City of Ketchum  
Planning & Building

### Design Review Application

APPLICANT INFORMATION			
Project Name: 780 1st Ave Multi-family project		Phone: 208.720.8244	
Owner: SV VENTURES LLC		Mailing Address: P.O. Box 5023 Ketchum ID 83340	
Email: reid.sanborn@evrealestate.com			
Architect/Representative: Daniel Hollis (Hollis Partners Architects)		Phone: 208.721.7160	
Email: daniel@hp-architects.com		Mailing Address: P.O. Box 1769, Sun Valley ID 83353	
Architect License Number: AR985372			
Engineer of Record: Galena Engineering Inc		Phone: 208.788.1705	
Email: sam@galena-engineering.com		Mailing Address: 317 N. River Street, Hailey ID 83333	
Engineer License Number: NA			
<i>All design review plans and drawings for public commercial projects, residential buildings containing more than four (4) dwelling units and development projects containing more than four (4) dwelling units shall be prepared by an Idaho licensed architect or an Idaho licensed engineer.</i>			
PROJECT INFORMATION

## **RESPONSE TO STAFF LETTER COMMENTS (August 16<sup>th</sup>, 2021):**

**Image shows perforated screening material on the roof to screen mechanical equipment.  
Posts will be bronze in color but set on the inside of screening material.**

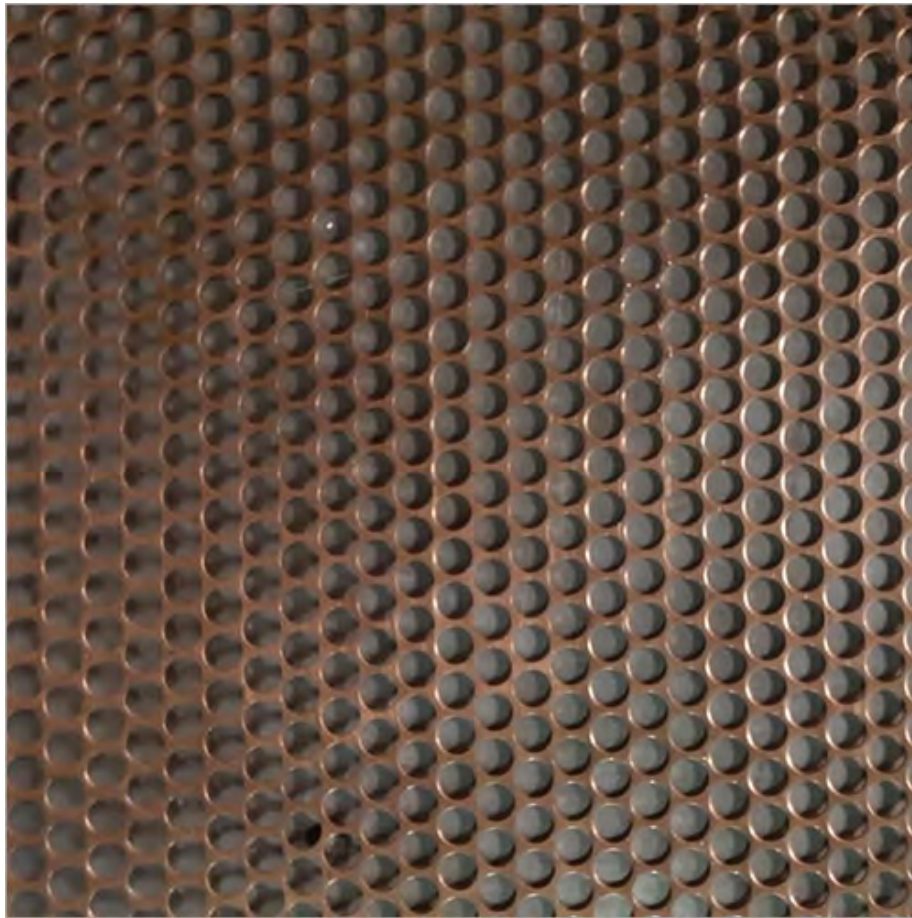
• **Screening of Rooftop Mechanical Equipment** – The sheet index for the plan set indicates inclusion of Sheet M1.3 – Roof HVAC Plan, however, the sheet is not included in the physical or electronic copies of the submittal. Sheets A3.1 and A3.2 indicate the location of the elevator roof; however, identification of materials is not included. Please clarify the intended screening, either materials or paint colors, for any rooftop mechanical equipment required for the building.

*Refer to attached Building elevation A3.1, A 3,2 and Roof plan showing the location of the 3' high perforated metal screening (Bronze). See image of perforated Screen below.*

1 FIRST FLOOR PLAN  
A2.1 SCALE: 1/4" = 1'-0"

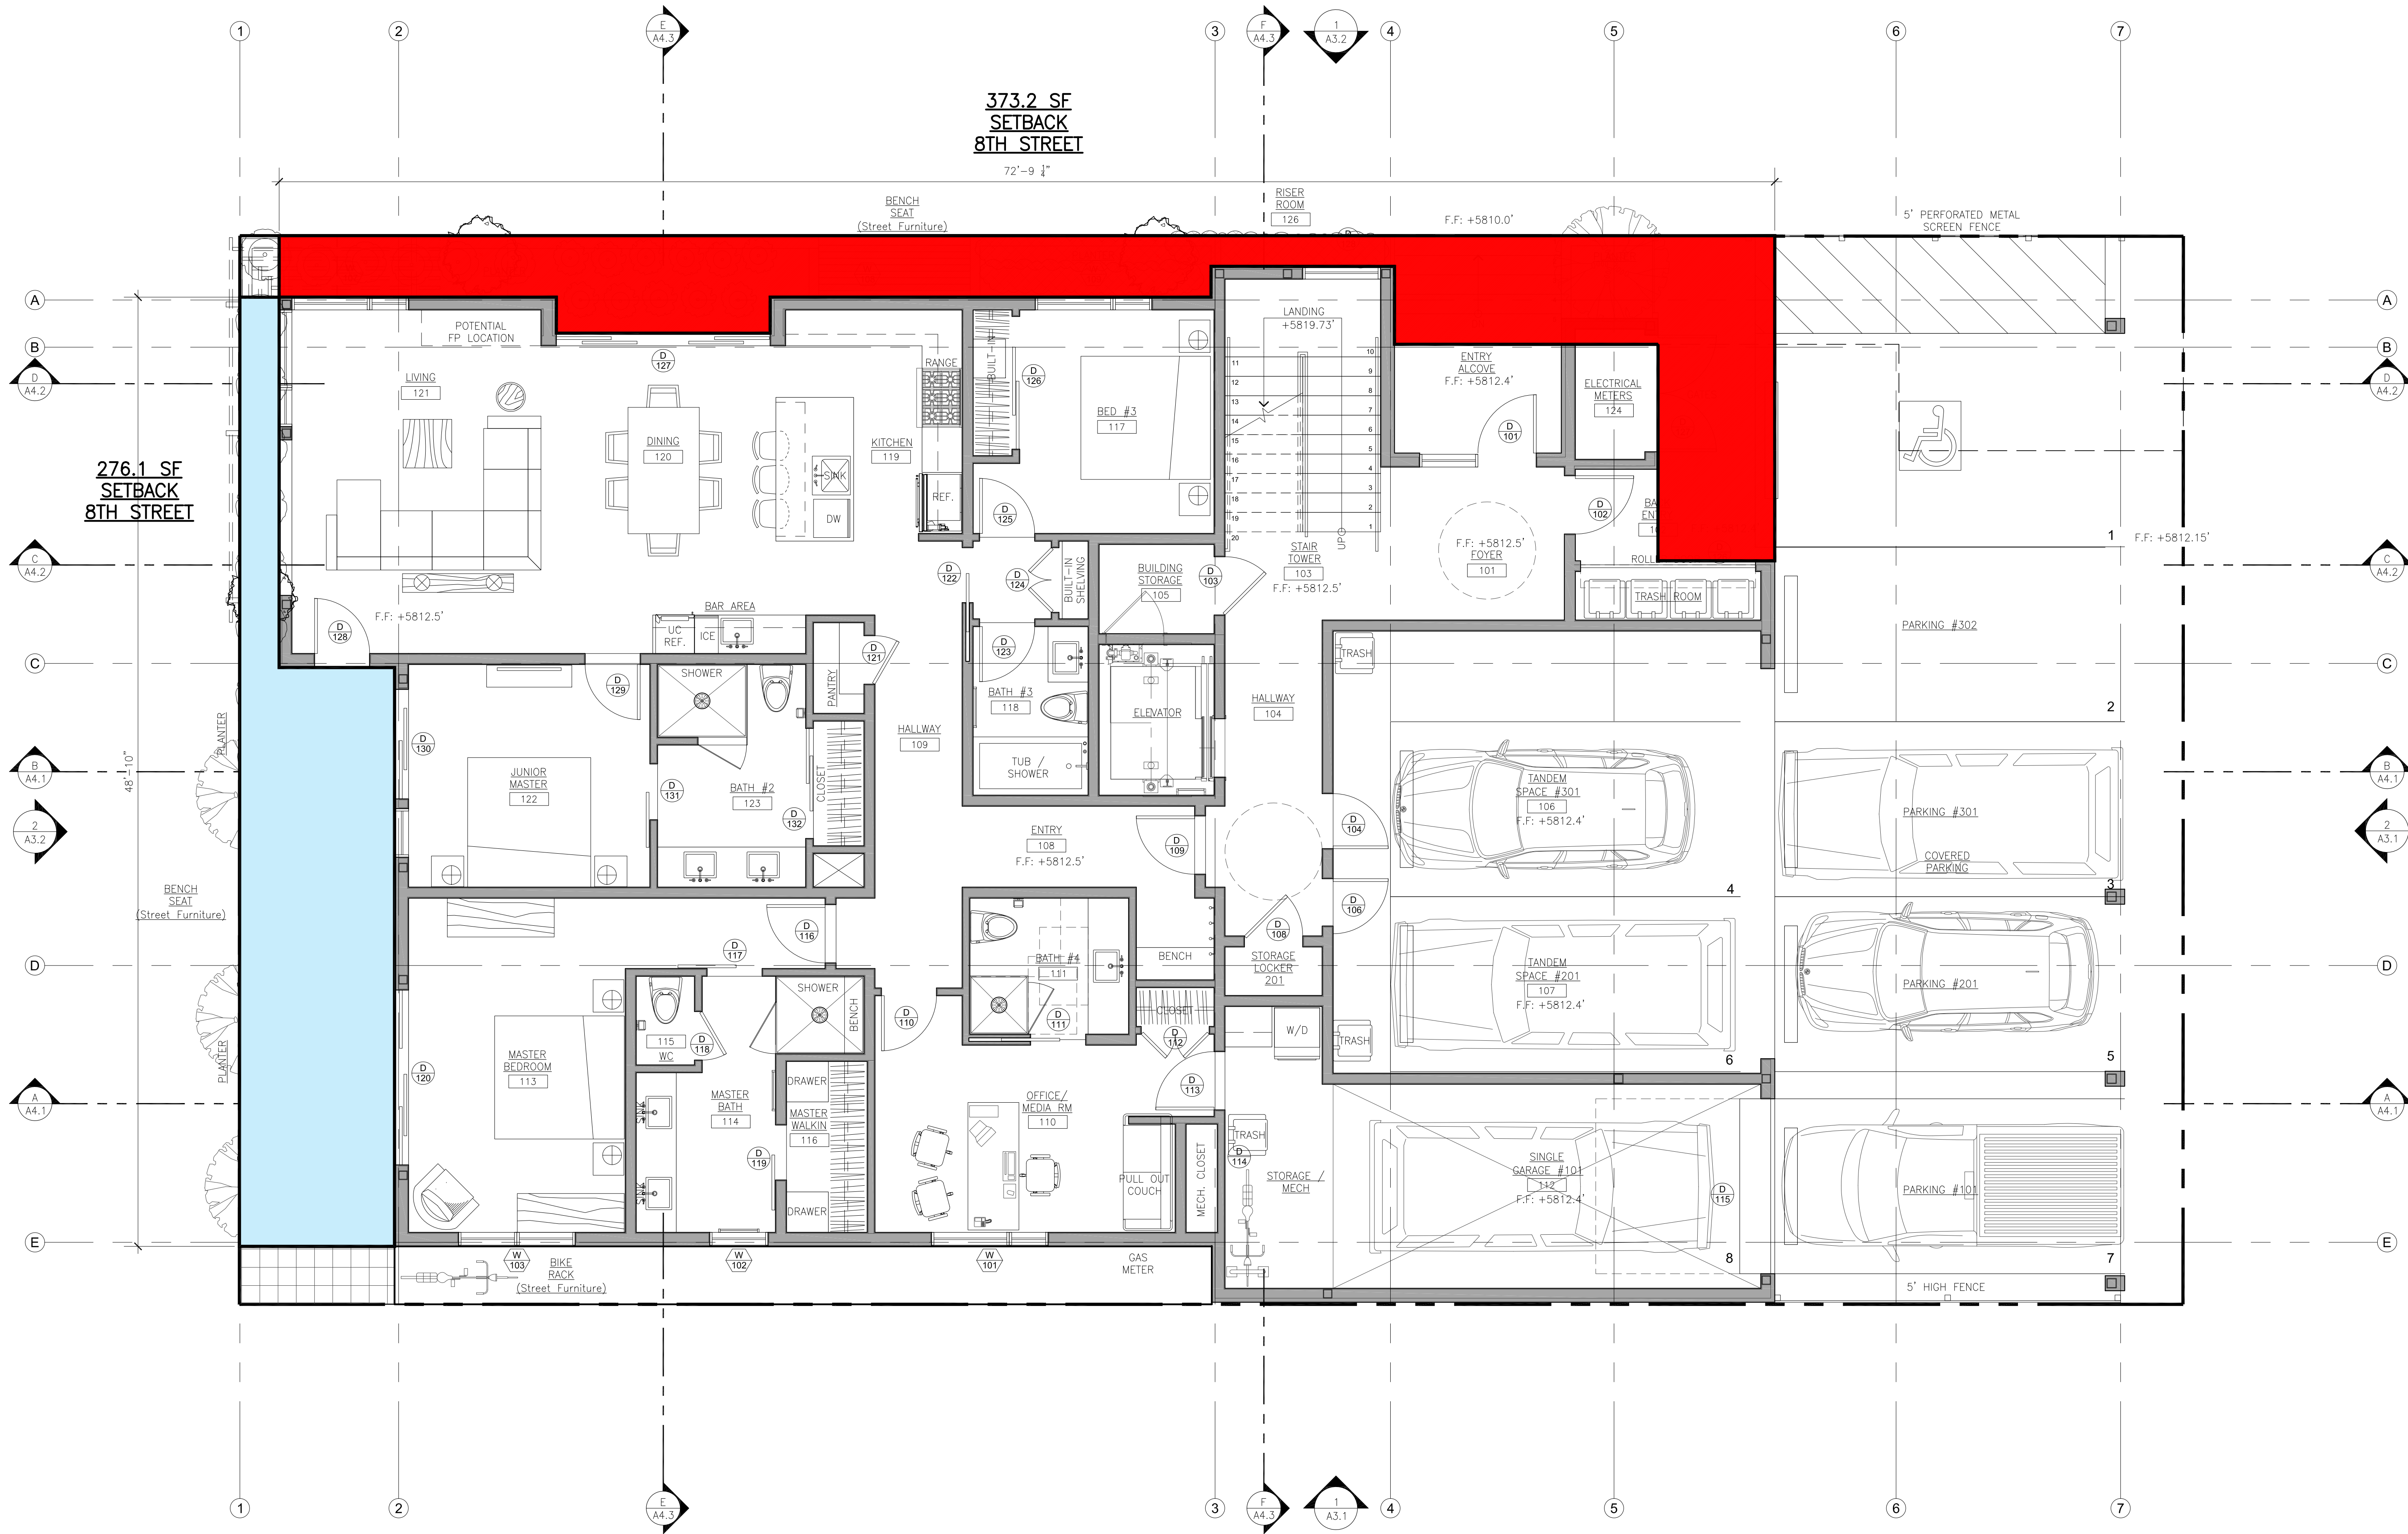
o **Initial Comment:** Sheets A2.1B – A2.3B demonstrate the setback calculation conducted by the applicant. Per the meeting on August 11, 2021, please revise the setback calculations by using the façade to measure the minimum requirement and the proposed setback at each floor. Please revise the noted sheets and the cover letter submitted with the application materials. Please note, on the first setback table on page 4 of the cover letter, the 1st Avenue side is referenced as the North Property Line, which is incorrect.

□ **Staff Comment:** Staff provided specific written direction to the applicant during a meeting on Wednesday, August 11, 2021. Sheet A2.1B has been updated accordingly, however, sheets A2.2B and A2.3B have not been updated per the direction provided by staff. Additionally, as noted in the initial comments, the cover letter still references 1st Avenue as the “North Property Line”, which is incorrect. Please update Sheets A2.2B and A2.3B and revise the cover letter accordingly.

*Please refer to the revised pdfs for A2.2B / A2.3B, these had a lock on the overwrite of the pdf I sent to you at the end of the day Friday. All the figures are the same as in the spreadsheet within the cover sheet. We may have a disconnect on where the building starts and stops on 8th, but we calculated the 1st floor as you explained the definition. There was typo in the spreadsheet, it still mentioned the North Property line and said 1st Ave (primary frontage) but should have said 1st Ave (West Property line), however calculations are correct and should not be held up for a typo.*

SECOND FLOOR  
UNITS 201, 202, & 203

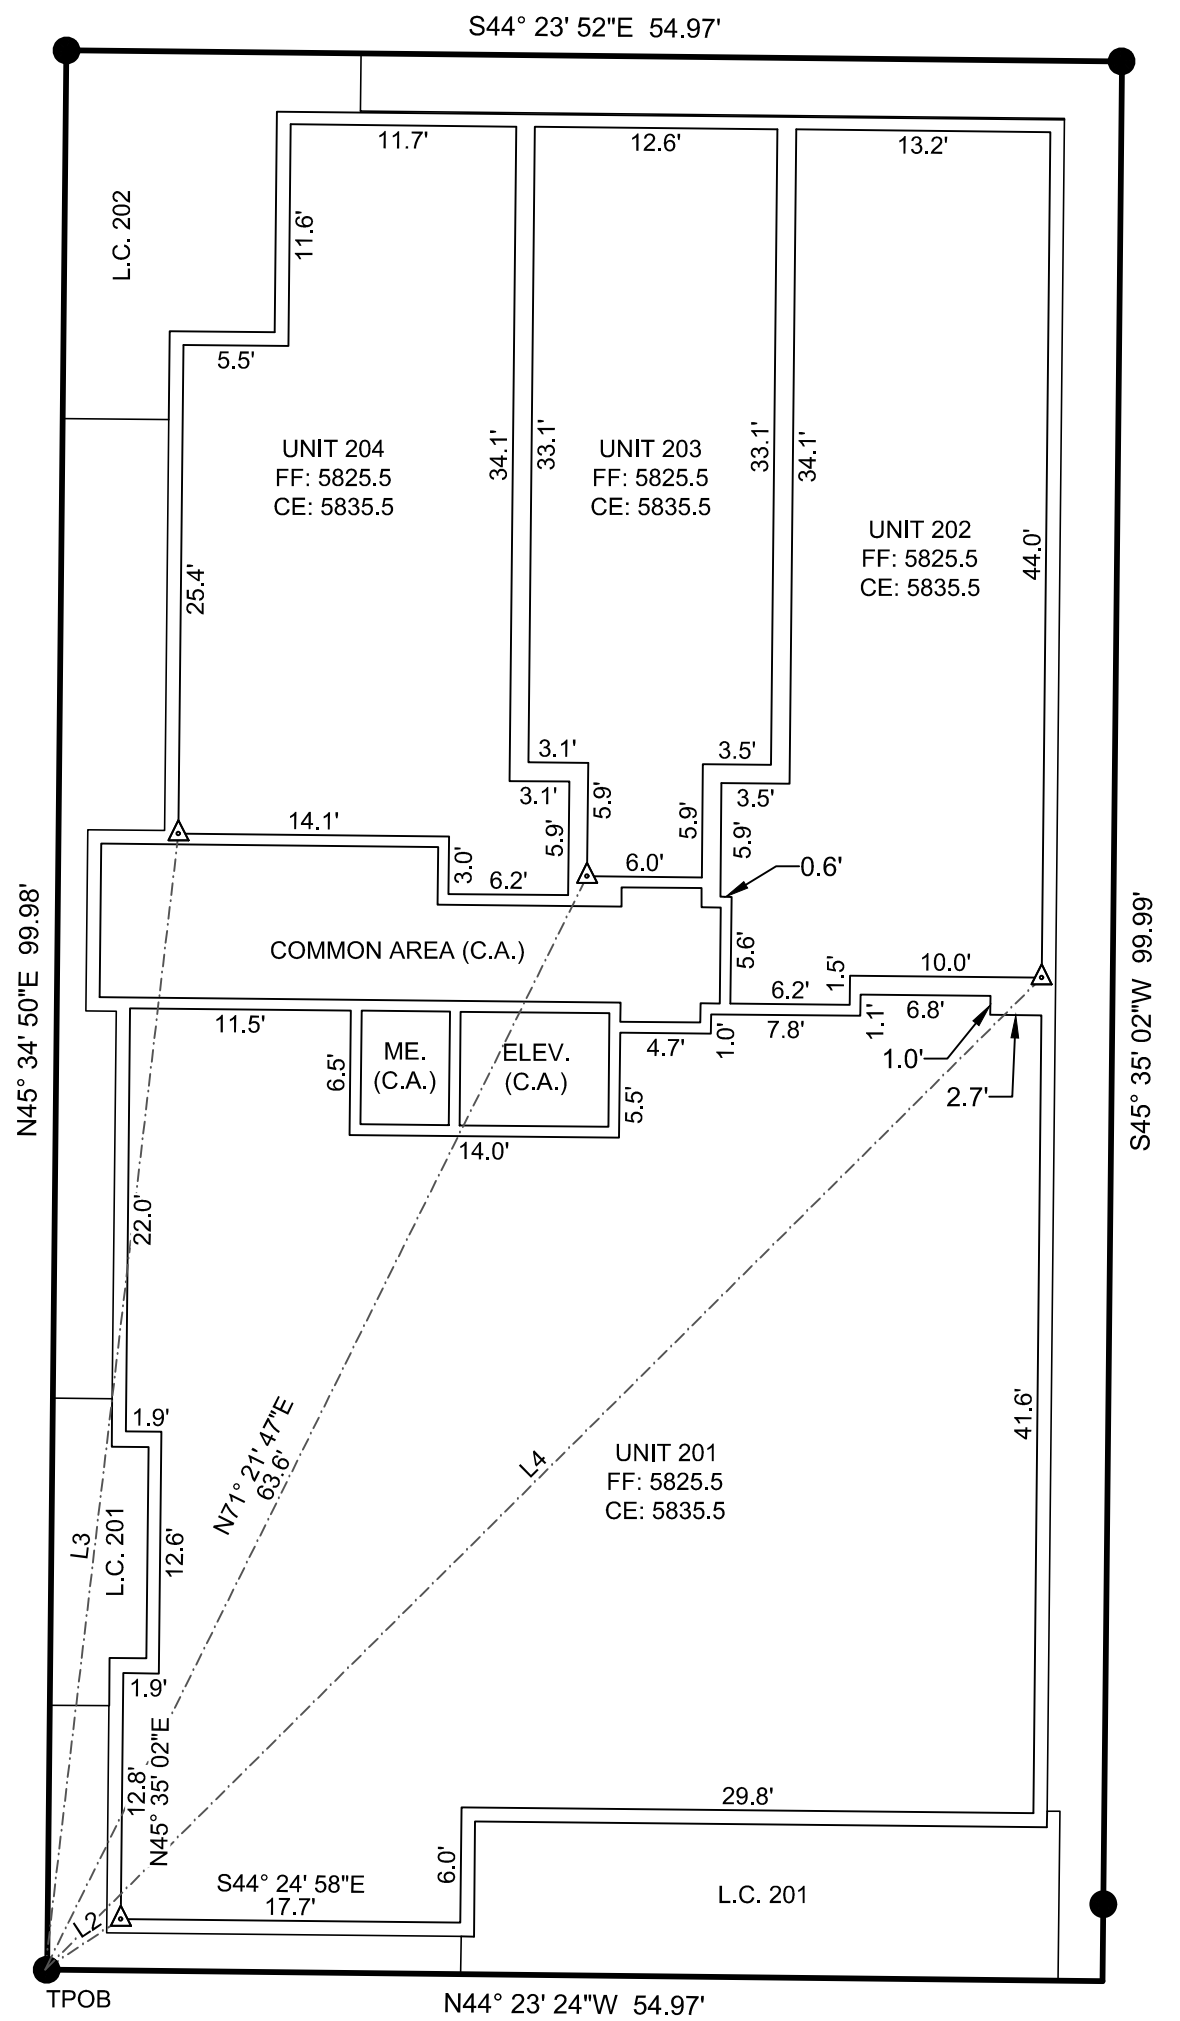
- o Sheet 2 outlines various limited common elements and parking spaces with either a double line or single line. It is staff's understanding that only the building or structure should be delineated with a double line and that limited common elements and common area outside the building or structure should be delineated with a single line. Please review Sheet 2 of the plat in comparison with the floor plans of the proposed building and revise accordingly.

- o Please add a plat note to Sheet 1 referencing the Blaine County Housing Authority deed restriction of Unit 203 for community housing.
